Re: RAWP Amendment #2
USAI Lighting Facility, Town of New Windsor, New York
BCP Site Number: C336087
C.T. Male Project No. 14.4337

FIGURE 1
RAWP AMENDMENT NO #2
USAI LIGHTING FACILITY
NEW WINDSOR, NY
2/10/16

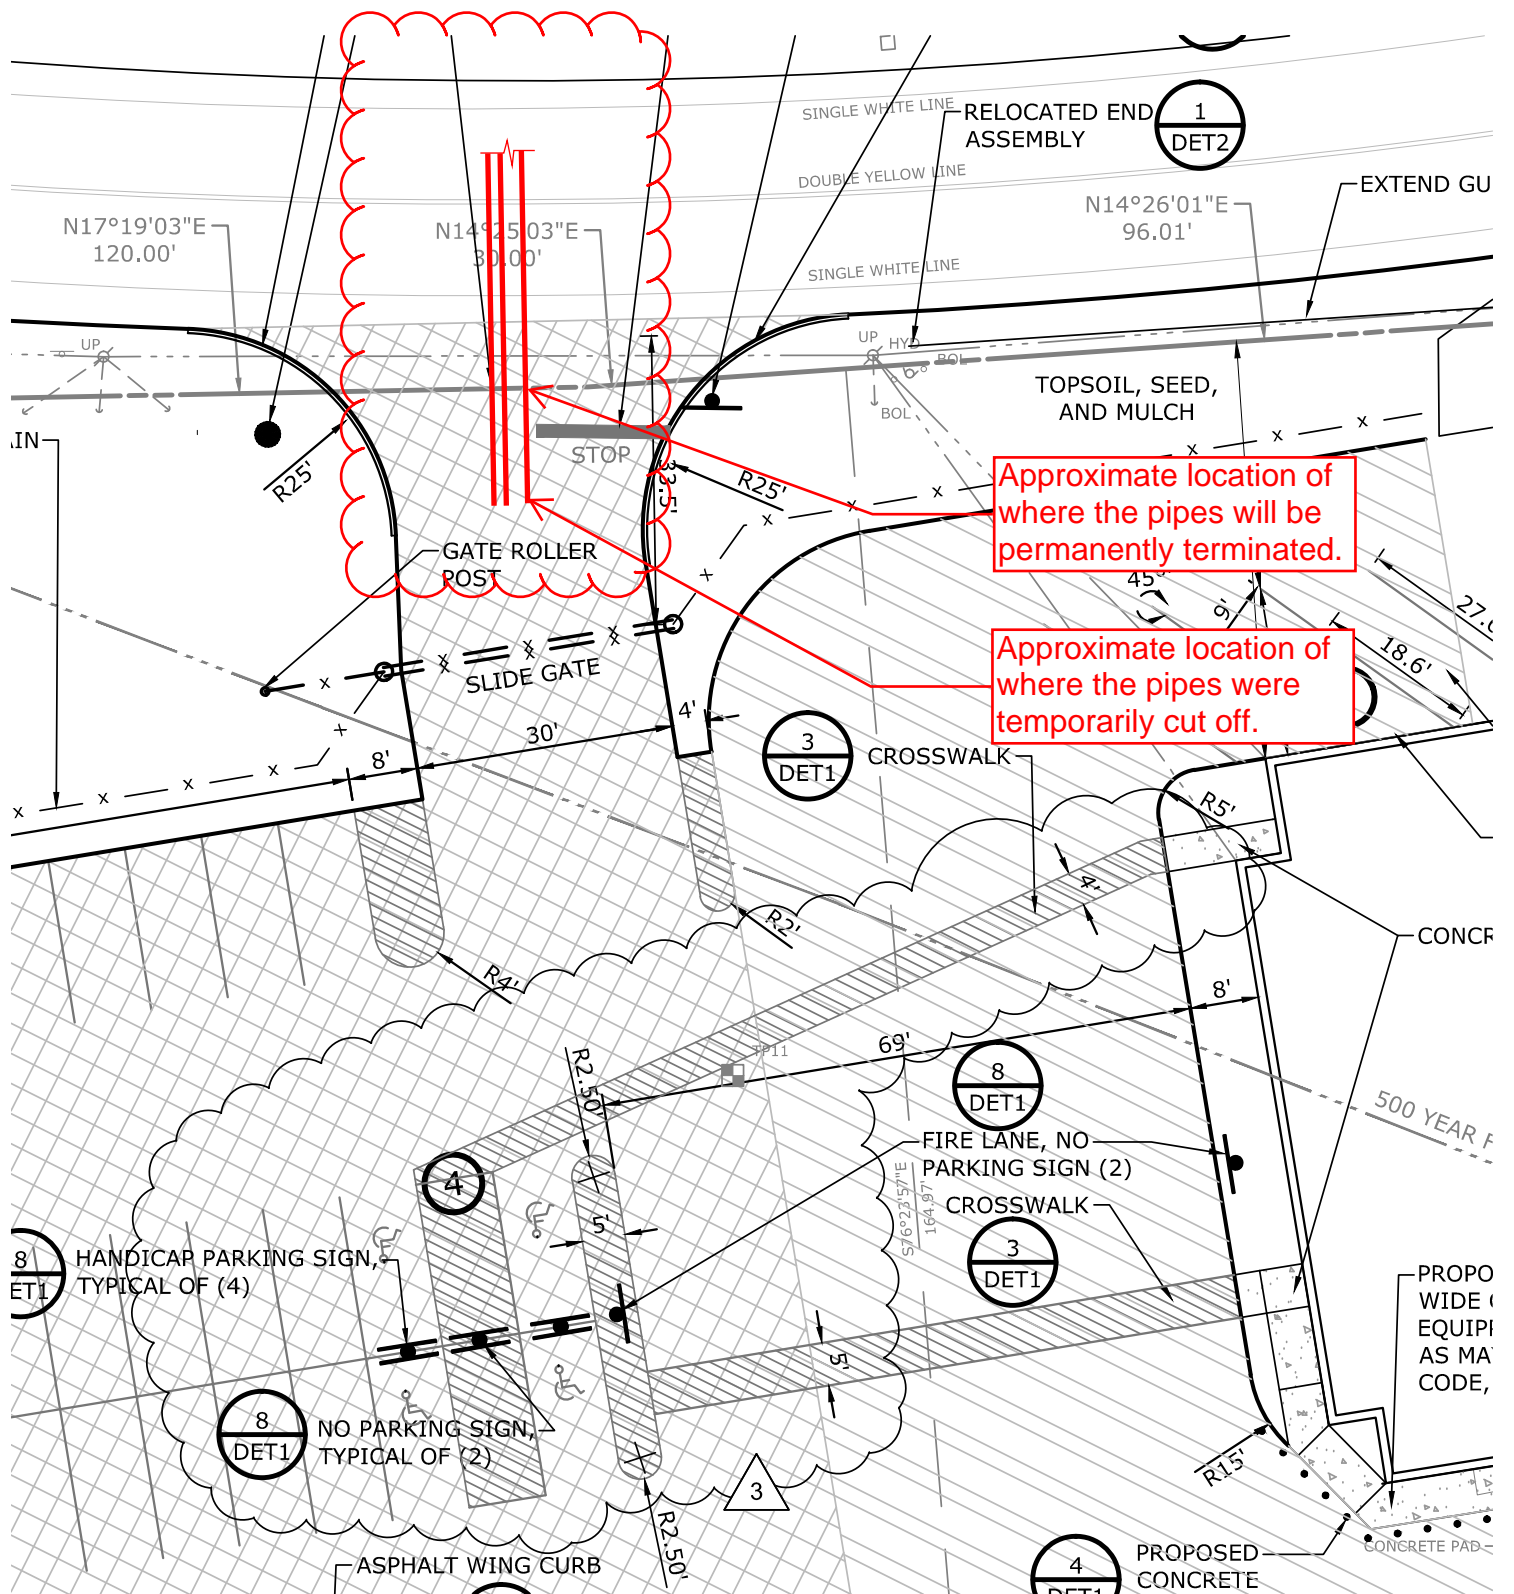
During the remedial action work and installation of utilities at the USAI Lighting facility, subgrade piping believed to be associated with the former Major Oil Storage Facility (MOSF) has been encountered. Three (3) of these pipes have been documented to continue off the property subject to the Brownfield Cleanup Program and travel off-site in the western direction. The attached figure shows the approximate location of the pipes in question.

Described in this proposal are the work tasks for permanently closing the former MOSF petroleum product piping at the property line. Because methods for addressing pipes leading off-site are not addressed within the Department approved Remedial Action Work Plan, we are seeking the Department's concurrence that this work may be amended to the May 27, 2015 Remedial Action Work Plan and approved for implementation under the BCP.

- Expose the subgrade piping back to the property line;
- Cut the pipe and capture remaining bulk product (if any) for proper disposal;
- Plug the inside of the pipe with an inflatable pipe pig;
- Seal the end of the pipe with hydraulic cement; and
- Locate the end of the pipes by measurements from existing site features.
